Office Action Summary	Application No. 10/536,599	Applicant(s) WATANABE ET AL.
	Examiner EUGENIA WANG	Art Unit 1726

DETAILED ACTION

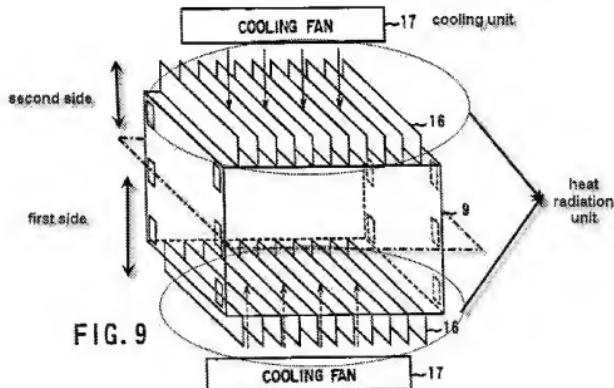
intake port (rectangular unlabeled sections, in fig. 9), that the composite second intake port is adjacent to the first intake port, barring specification as to what constitutes adjacent. Office personnel are to give claims their broadest reasonable interpretation in light of the supporting disclosure. *In re Morris*, 127 F.3d 1048, 1054-55, 44 USPQ2d 1023, 1027-28 (Fed. Cir. 1997). Also, limitations appearing in the specification but not recited in the claim are not read into the claim. See *In re Zletz*, 893 F.2d 319, 321-22, 13 USPQ2d, 1320, 1322 (Fed. Cir. 1989). Again, since such a second intake port is on the upper half, it is on a second side of the power generation unit. See annotated figure (fig. 9 of Chizawa et al.) below for interpretation taken:

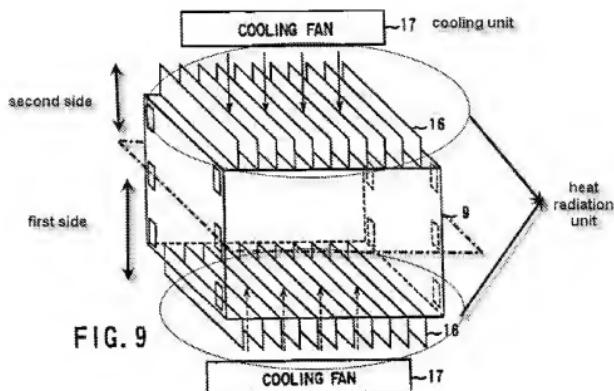
first intake port would necessarily exist in the embodiment of fig. 9, or else the reactants would not be able to be delivered to the cells within the stack.) It is noted that such an intake port is located on the second side of the fuel cell (upper half). Fig. 9 shows that there are cooling fans [17] (cooling units) that direct (suck) air to cool the radiation fins [16] (heat radiation unit with heat transfer portion) (fig. 9; col. 12, lines 45-55). It is noted that the upper cooling fan [17] (cooling unit) is located on the second side (upper half of the fuel cell system) and directs the air of the portion of the cooling unit that lies that second side. It can be interpreted that the openings defined by the upper radiation fins [16] constitute a composite second intake port (on the power generation unit, as it is attached to the fuel cell stack [9]), wherein, as such a place is near that of the first intake port (rectangular unlabeled sections, in fig. 9), that the composite second intake port is adjacent to the first intake port, barring specification as to what constitutes adjacent. Office personnel are to give claims their broadest reasonable interpretation in light of the supporting disclosure. *In re Morris*, 127 F.3d 1048, 1054-55, 44 USPQ2d 1023, 1027-28 (Fed. Cir. 1997). Also, limitations appearing in the specification but not recited in the claim are not read into the claim. See *In re Zletz*, 893F.2d 319, 321-22,13 USPQ2d, 1320, 1322 (Fed. Cir. 1989). Again, since such a second intake port is on the upper half, it is on a second side of the power generation unit. See annotated figure (fig. 9 of Chizawa et al.) below for interpretation taken:
